# Addendum No. 03

May 8, 2024

## Universal Transitional Kindergarten Lincoln Elementary School

**PBK PROJECT NO.:** 220486  
**DSA FILE NO.:** 20-30  
**DSA APPLICATION NO.:** 02-121587

CS2.1

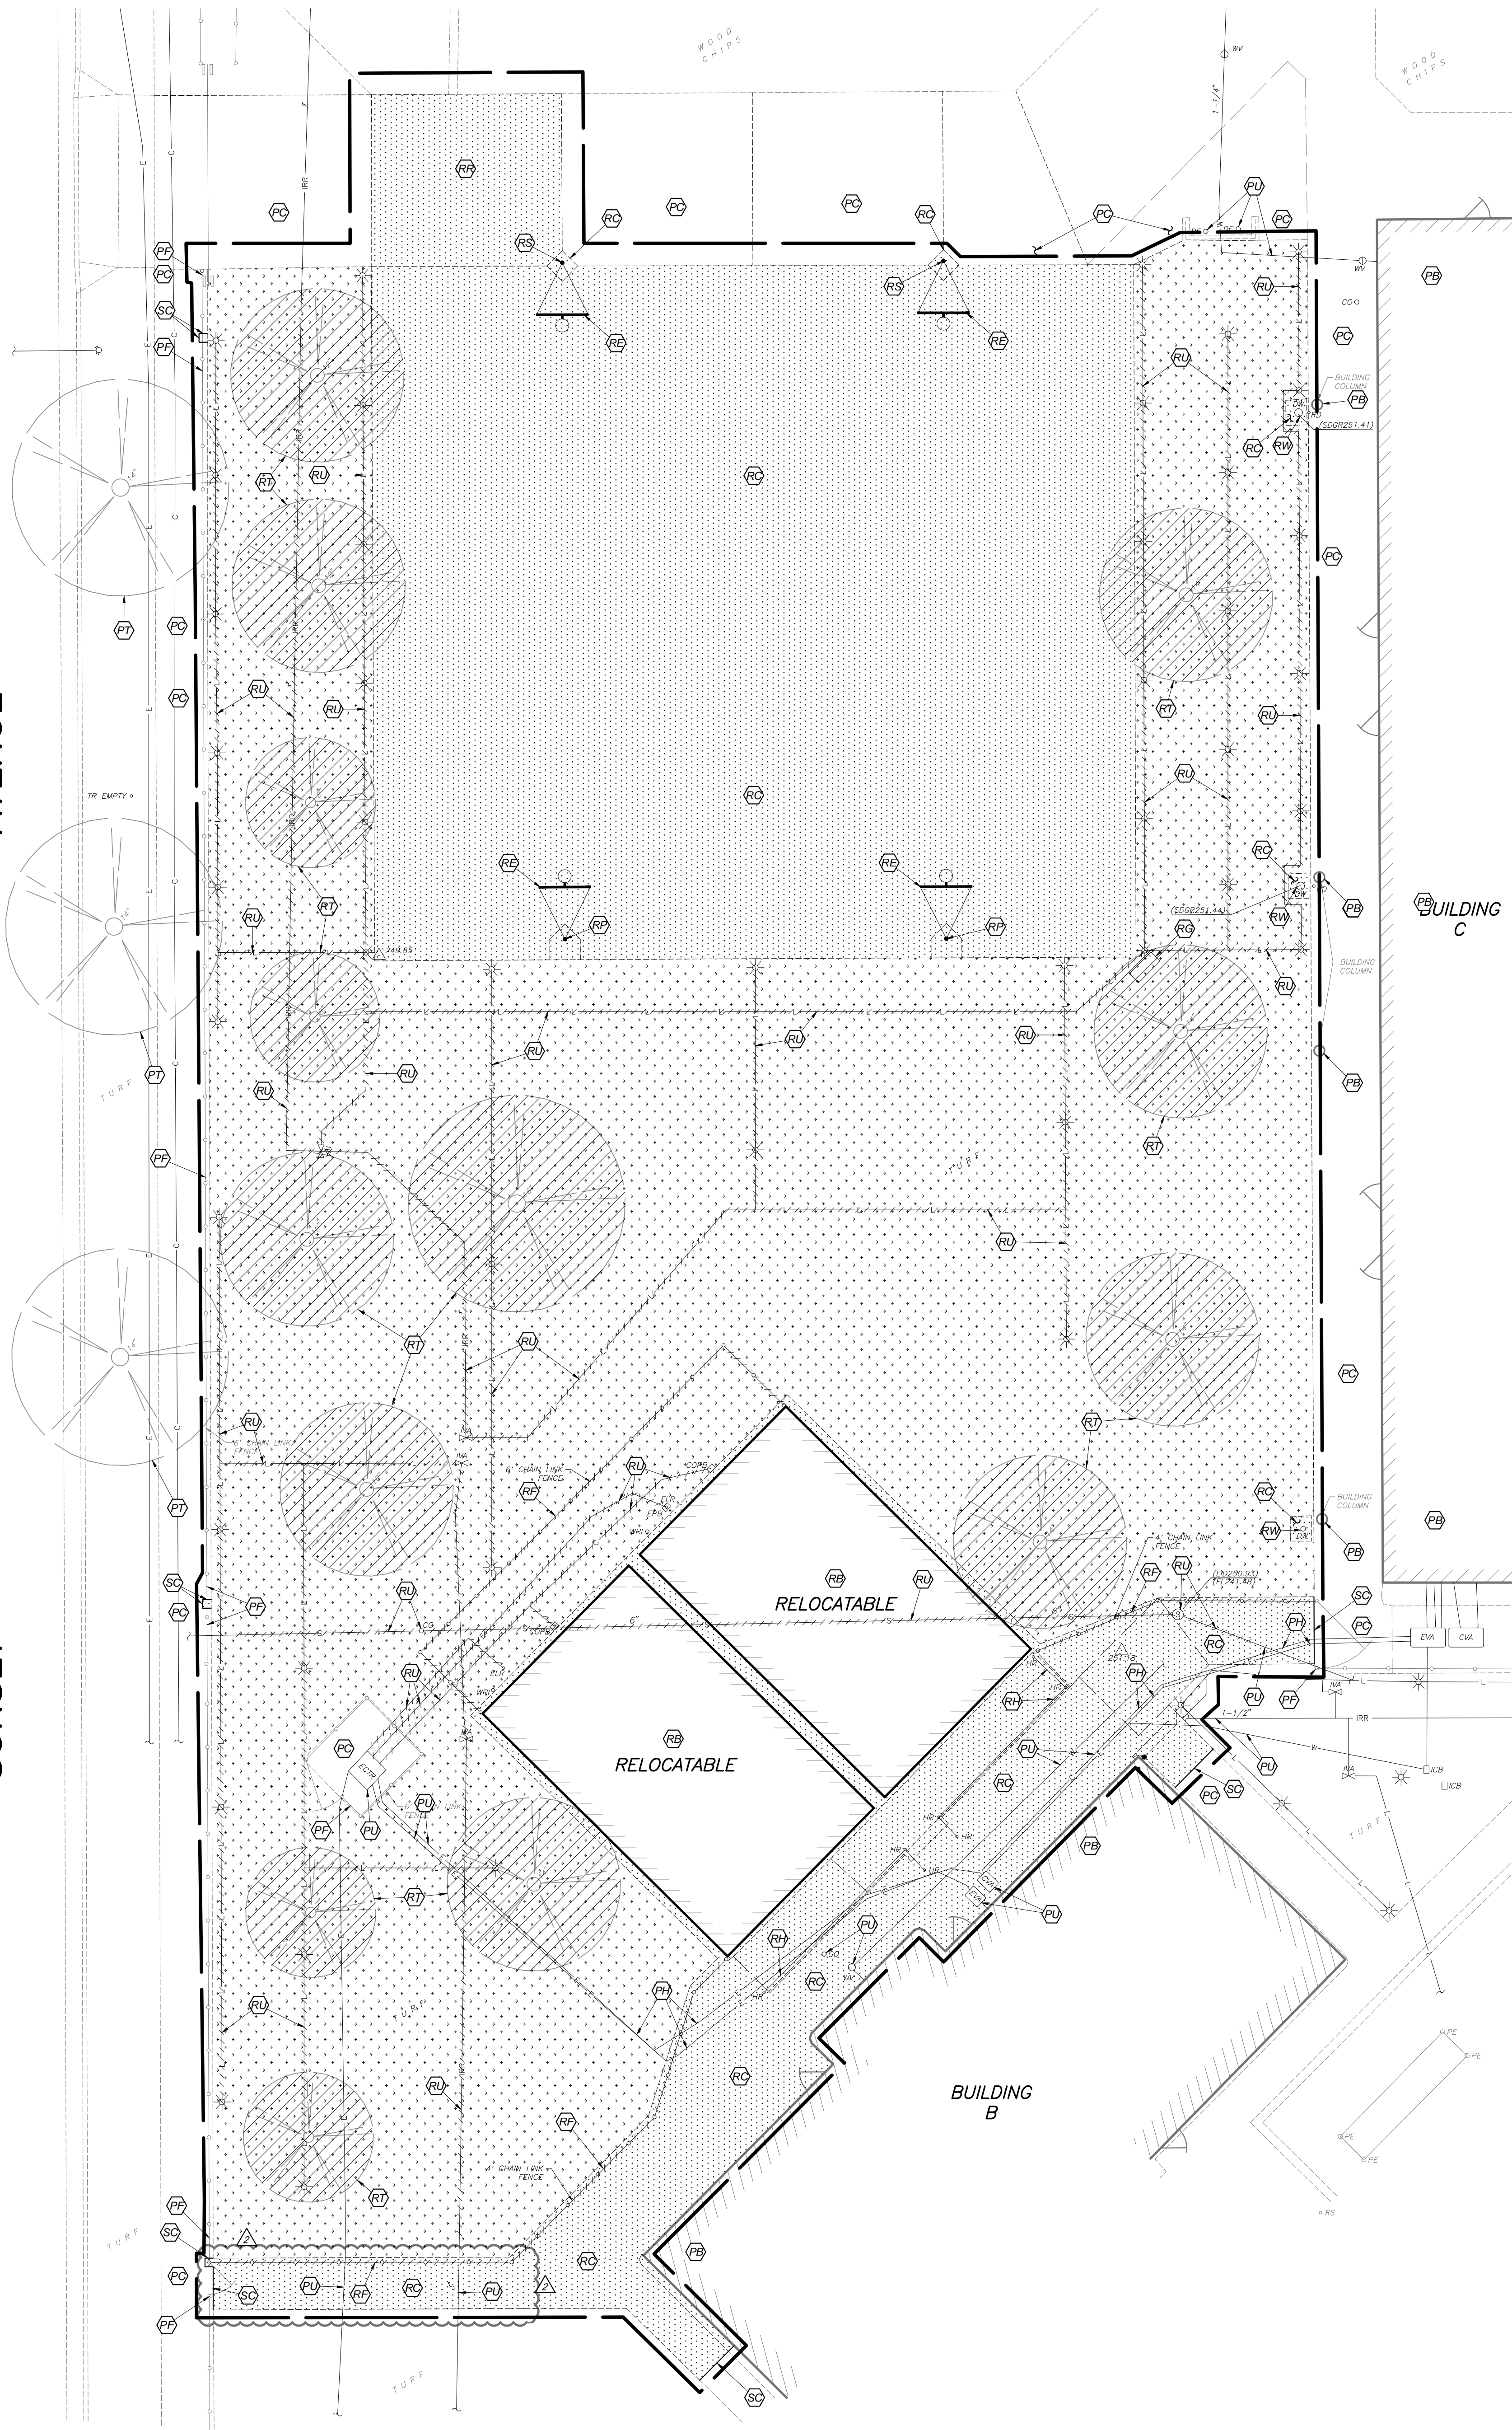
**3-01 CS2.1 – DEMOLITION PLAN**, revise as follows:

- a. Additional concrete removal and revisions have been clouded with delta 2. Remove and replace with attached drawing.

# CS4.1

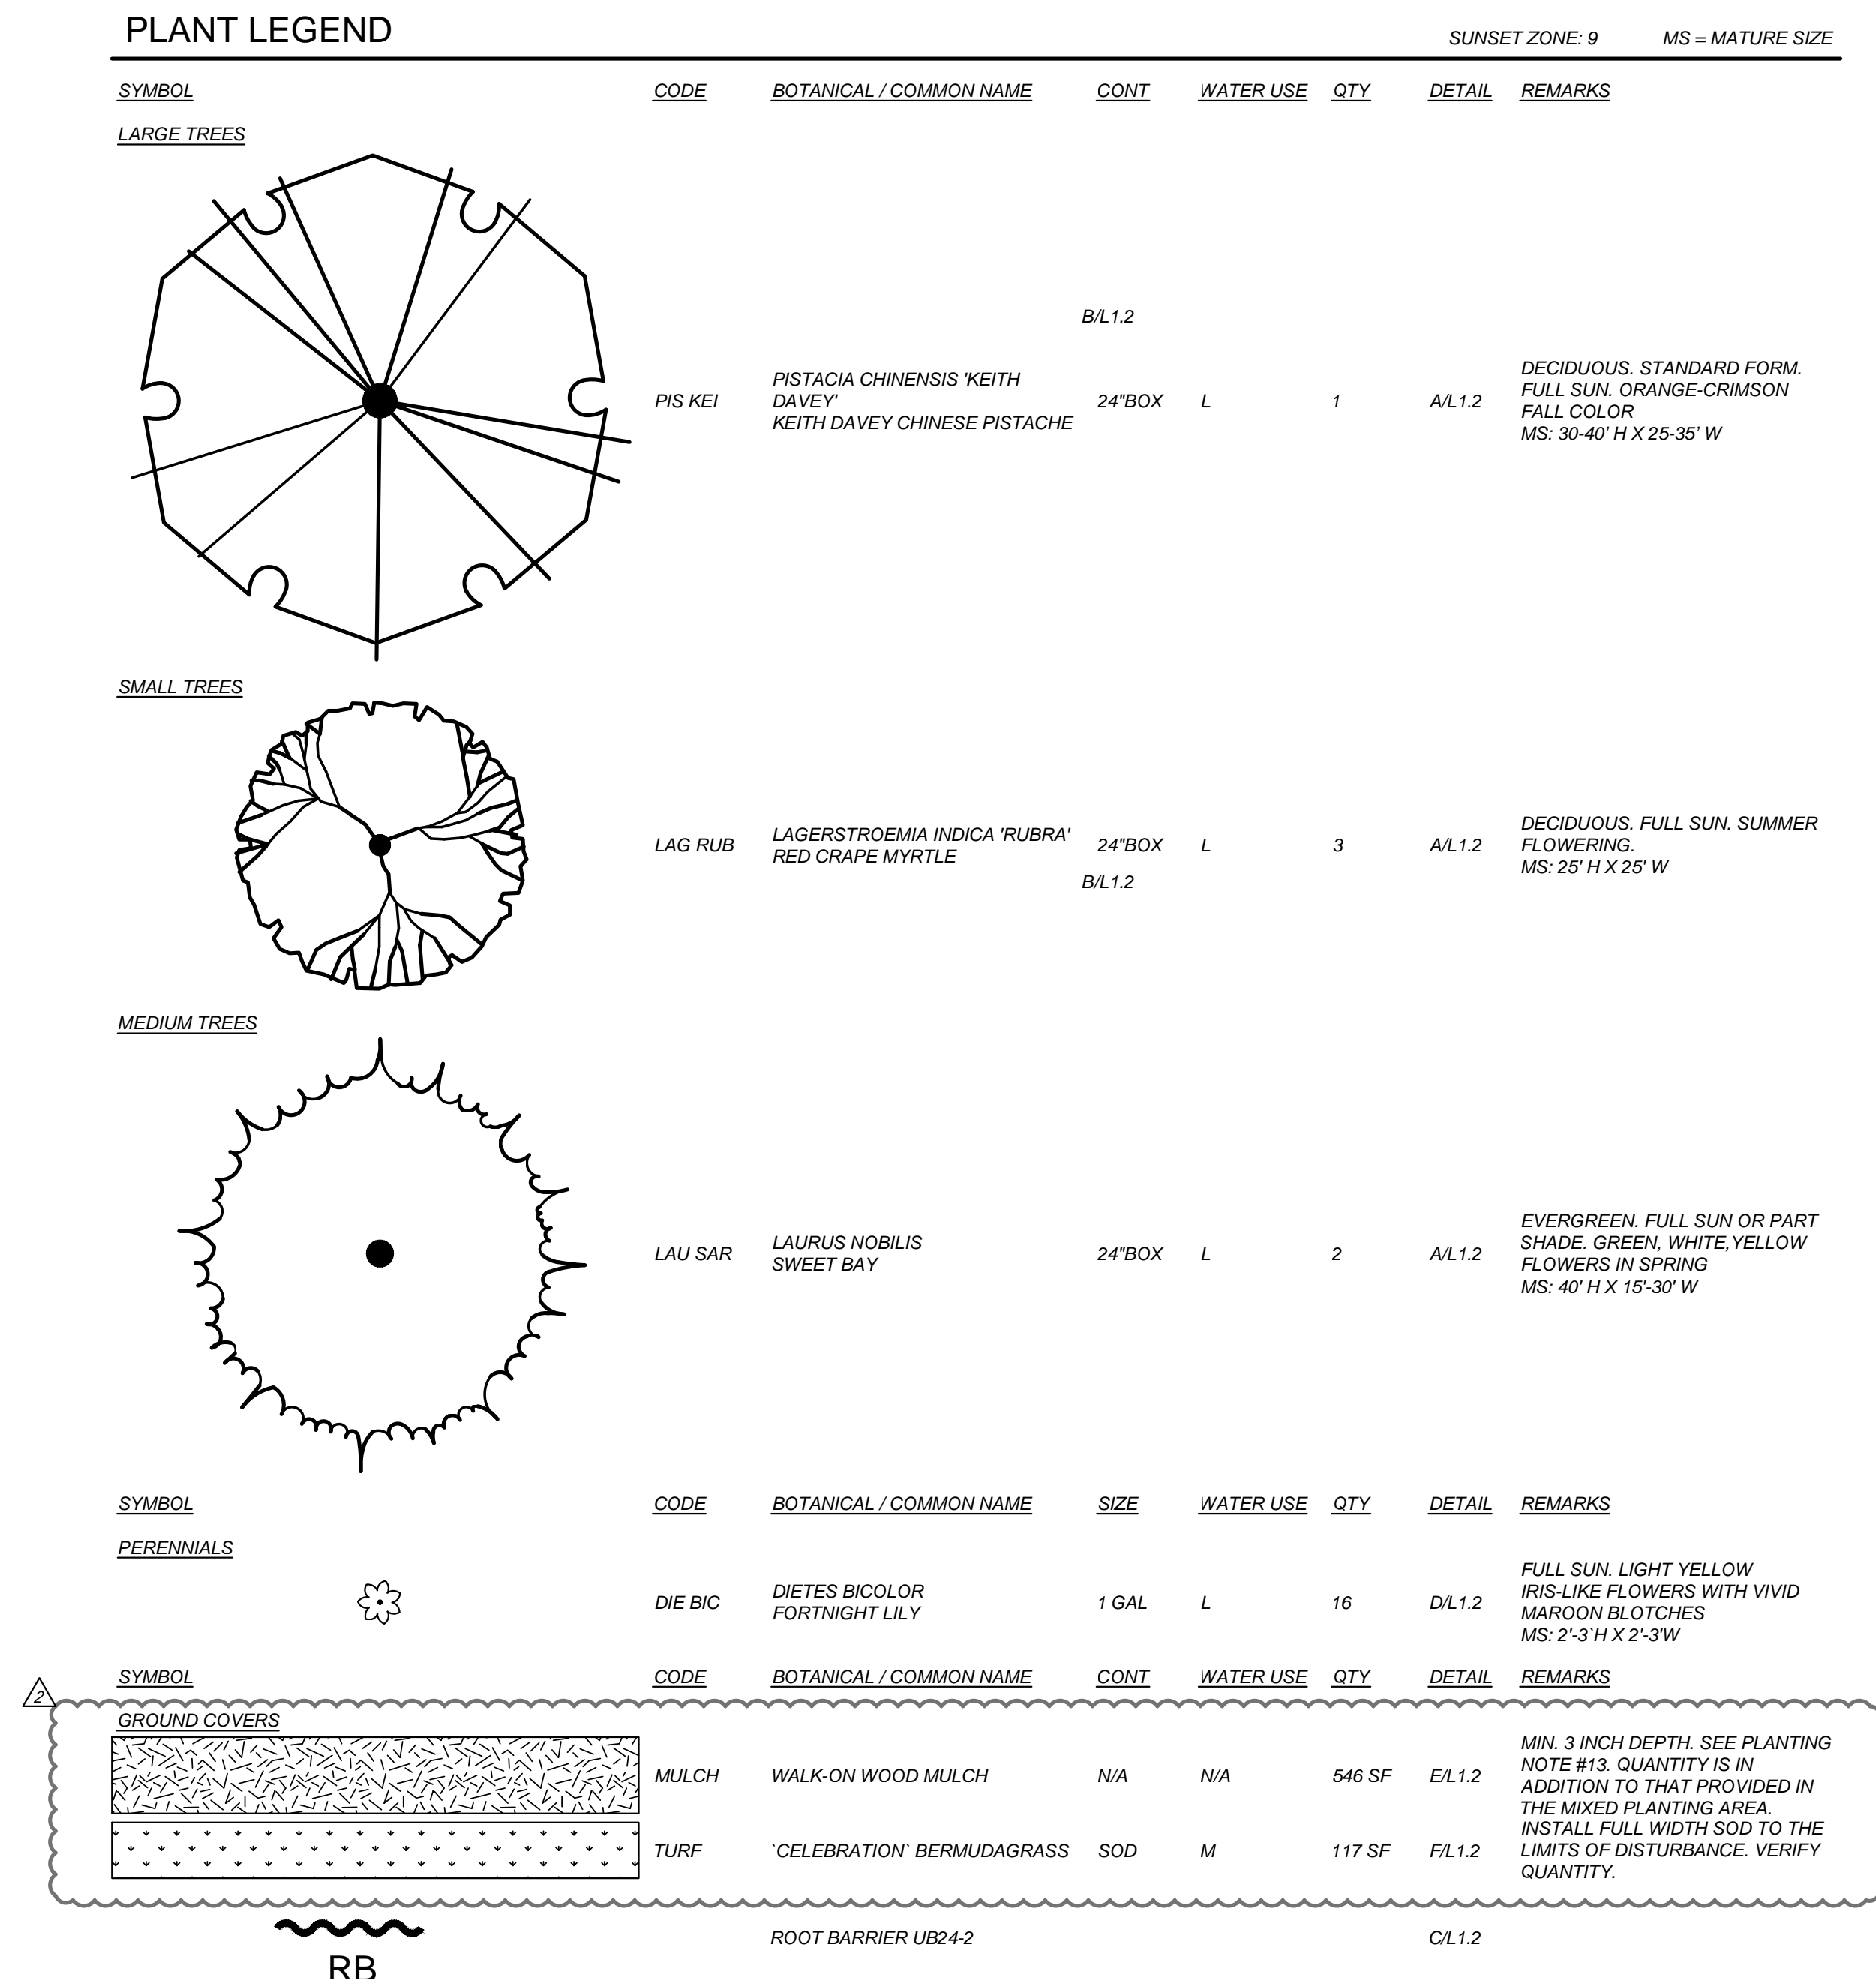
**3-03 CS4.1 – GRADING AND DRAINAGE PLAN**, revise as follows:

- a. Revised grading within play equipment areas and sidewalks. Revisions have been clouded with delta 2. Remove and replace with attached drawing.

## L1.1

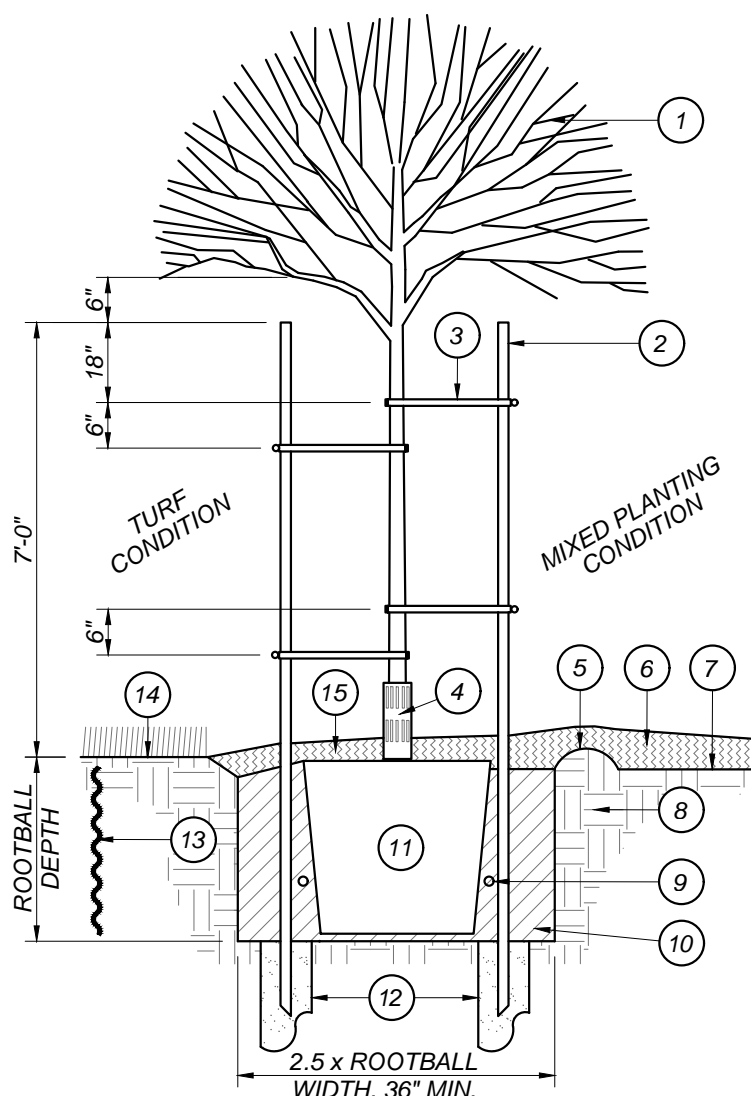
**3-04 L1.1 – PLANTING PLAN**, revise as follows:

- a. Relocate large tree at revised area; Revisions have been clouded with delta 2. Remove and replace with attached drawing.

## F TURF SOD INSTALLATION

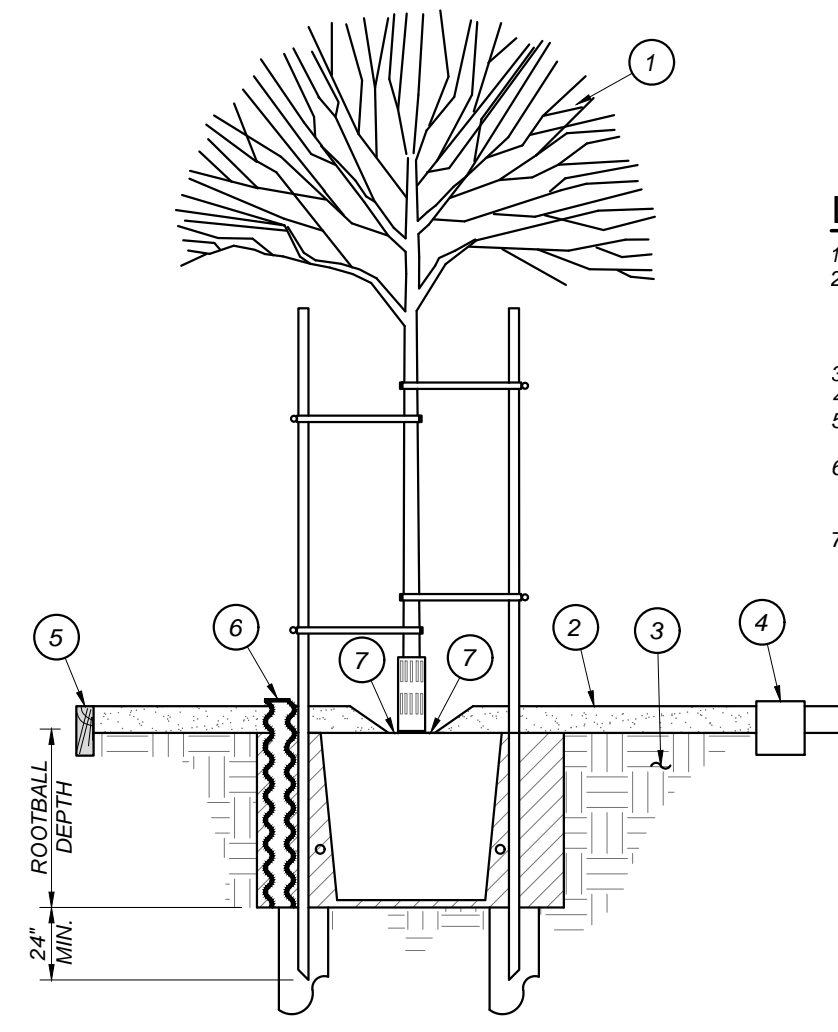
- b. Added turf repair detail F, and revisions have been clouded with delta 2. Remove and replace with attached drawing.

## E MULCH DETAIL

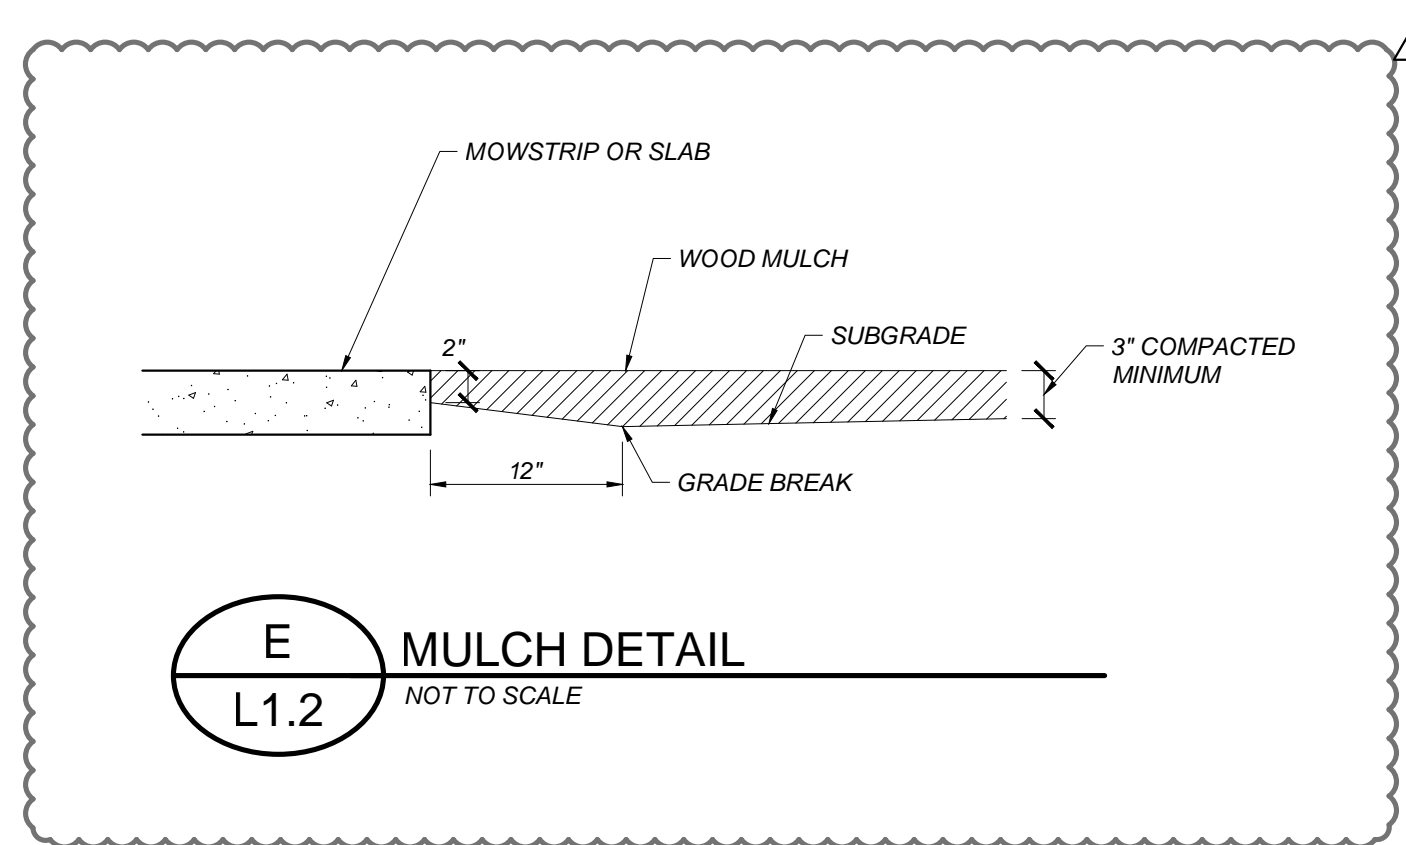
- a. Added mulch detail E, and revisions have been clouded with delta 2. Remove and replace with attached drawing.
